Subject: Duke Energy Corporation
Catawba Nuclear Station Unit 1
Docket No.: 50-413
Core Operating Limits Report (COLR)
Catawba Unit 1 Cycle 13, Revision 18

Catawba Unit 1 Cycle 13**Core Operating Limits Report
Revision 18****October 2000****Duke Power Company**

IMPLEMENTATION INSTRUCTIONS FOR REVISION 18

Catawba 1 Cycle 13 Core Operating Limits Report**Figure 3**

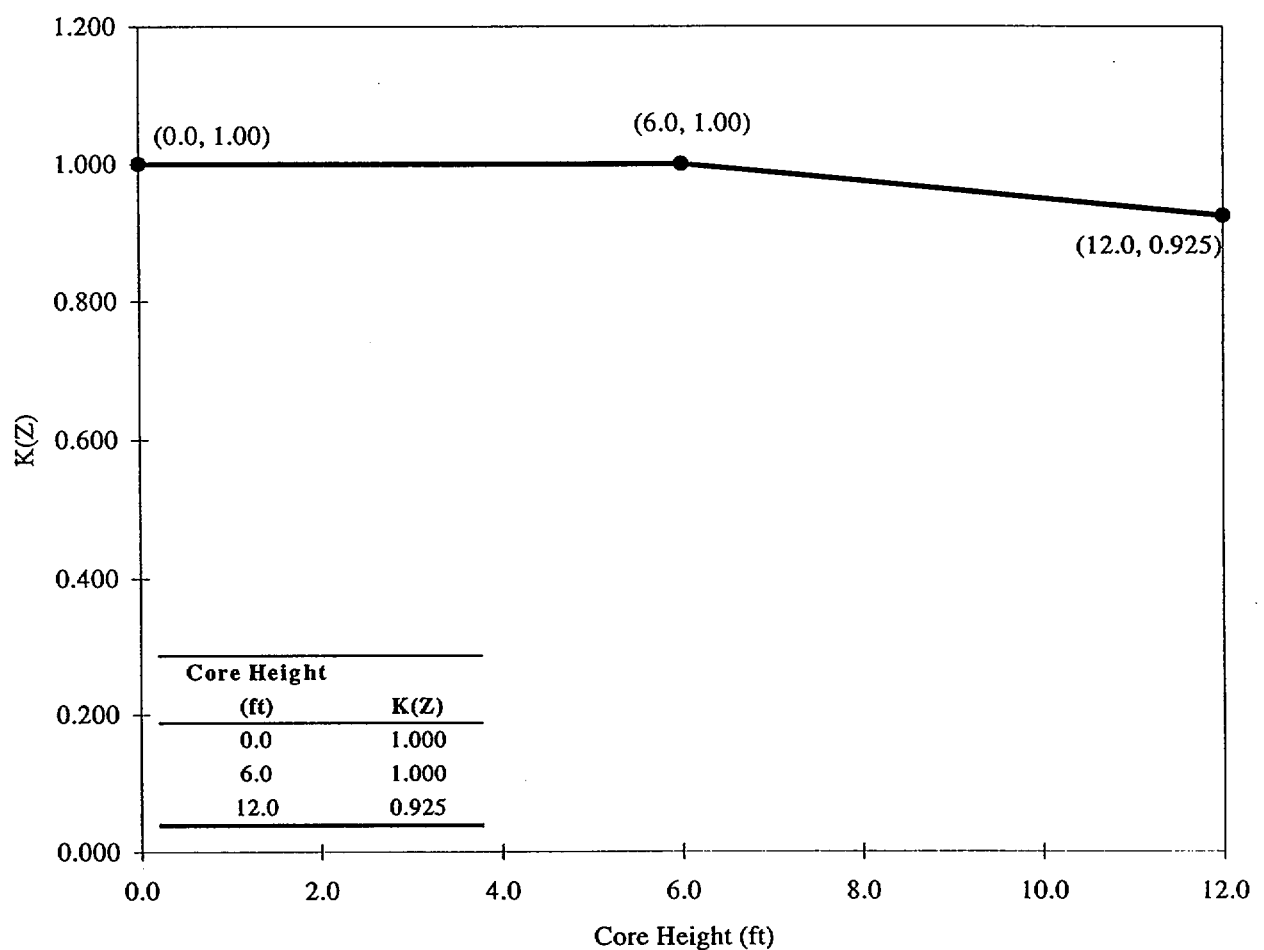
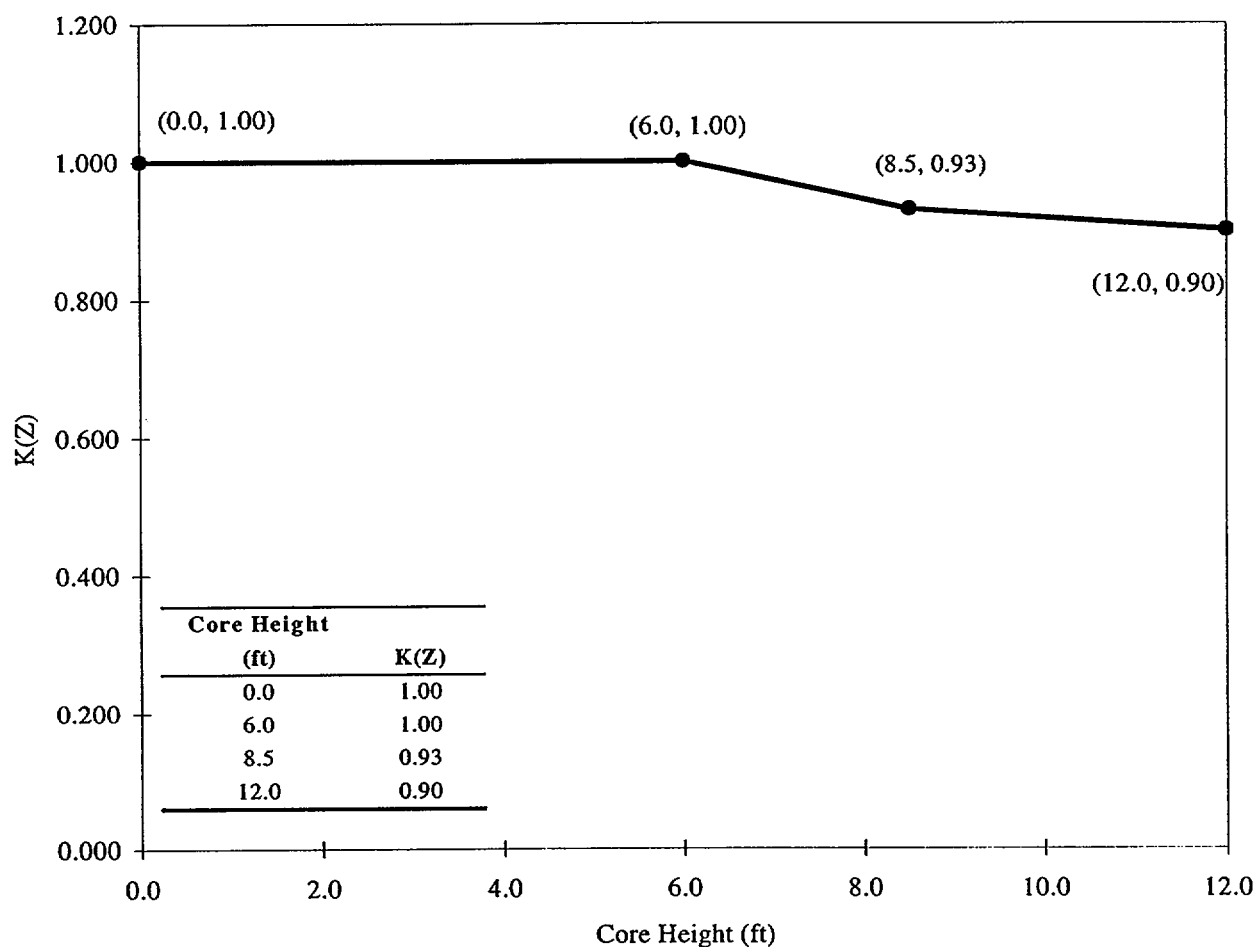
1. The K(Z) curves for MkbW and Westinghouse RFA fuel, Figures 3 and 4, have been updated to correspond to the Westinghouse LOCA analyses.
2. Table 1 has been added to clarify the Withdrawal Steps and Sequence for Control and Shutdown Banks. This table was added to alleviate the need to calculate bank overlap limits for each allowable All Rods Out parked position.
3. The minimum required boron concentration for the RWST, Cold Leg Accumulator, and Spent Fuel Pool was lowered by 50 ppm to be consistent with Unit 2, and to provide a larger boron operating range. The maximum concentration limits have not been adjusted.
4. The FAH LCO MARP table has been relocated from Appendix A, Table 7 to Table 3. The Appendix A tables now contain only cycle-specific power distribution surveillance Monitoring Factors. Additional peaking limits for axial peaks at 3.0 and 3.25 were also added to Table 3.

Note: Figure 3 represents the $K(Z)$ function analyzed for Mk-BW fuel in the C1C13 Maneuvering Analysis (CNC-1553.05-00-0337). This $K(Z)$ function is based on Appendix K LOCA methodology and is more conservative than the current $K(Z)$ function required by the BELOCA methodology referenced in Technical Specification 5.6.5.

Note: Figure 4 represents the $K(Z)$ function analyzed for RFA fuel in the C1C13 Maneuvering Analysis (CNC-1553.05-00-0337). This $K(Z)$ function is based on Appendix K LOCA methodology and is more conservative than the current $K(Z)$ function required by the BELOCA methodology referenced in Technical Specification 5.6.5.

Catawba 1 Cycle 13 Core Operating Limits Report**Figure 5****Percent of Rated Thermal Power Versus Percent Axial Flux Difference Limits**

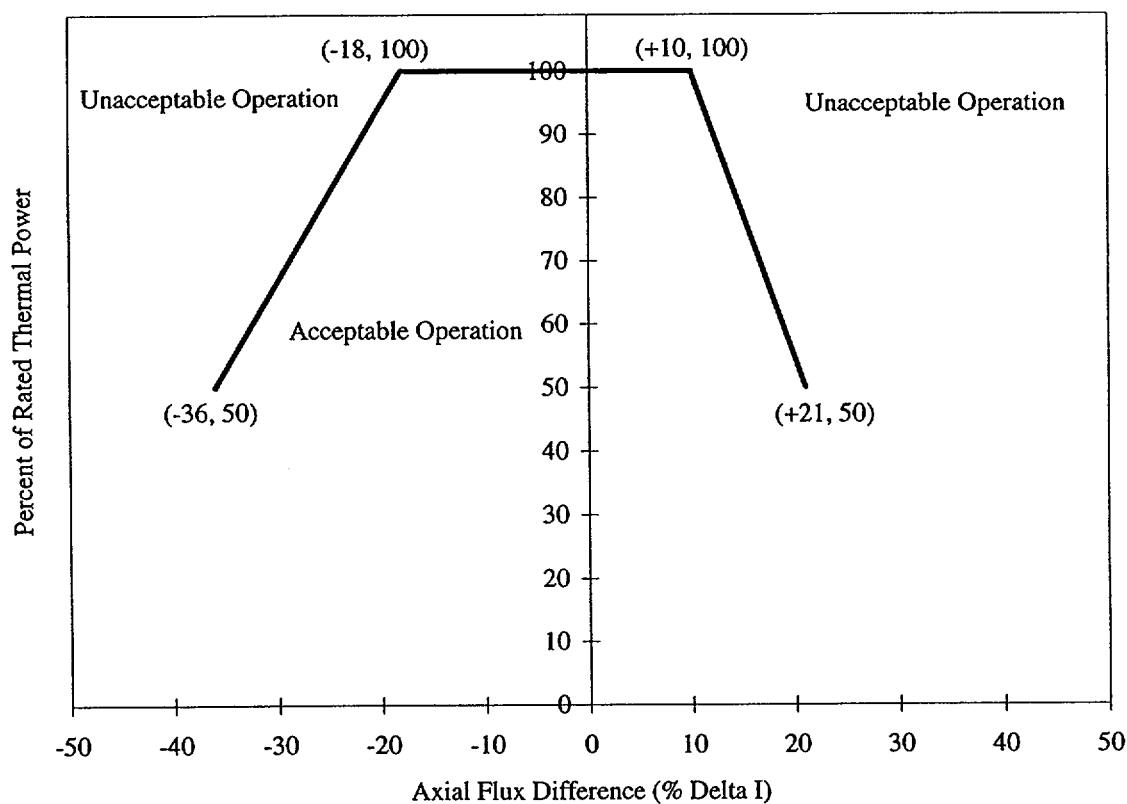
5. The Full Power Negative AFD limit shown in Figure 5 has been reduced from -20% to -18%.
6. The power distribution surveillance data contained in Appendix A has been updated for the new core. The tables contained in Appendix A were renumbered after inserting Table 1 for the RCCA Withdrawal Steps and Sequence, and moving Appendix A, Table 7 to Table 3.

2.7.1 The Axial Flux Difference (AFD) Limits are provided in Figure 5.
